2 Type of change

Actuator dimensions have changed, see table below

LPH					0118.2163	
creation date	created by	release date	released by	notification no.	revision	page
2013-03-12	bisanger	2013-03-19	bisanger	24506		1 of 1

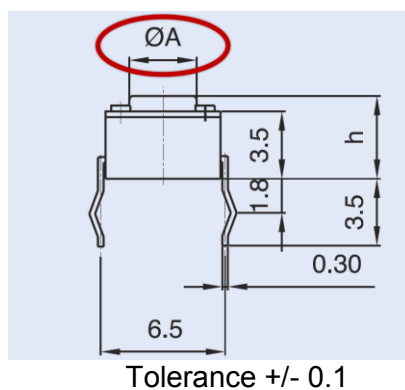
Part no.	Dimension A old [mm]	Dimension A new [mm]
1301.9303	Ø 3.2	Ø 3.3
1301.9305	Ø 3.1	Ø 3.3
1301.9307	Ø 3.0	Ø 3.4

Redesign and improvement of tooling

Form: Yes, see chapter 3
Fit: Yes, see chapter 3
Function: No influence
Production Site: No influence
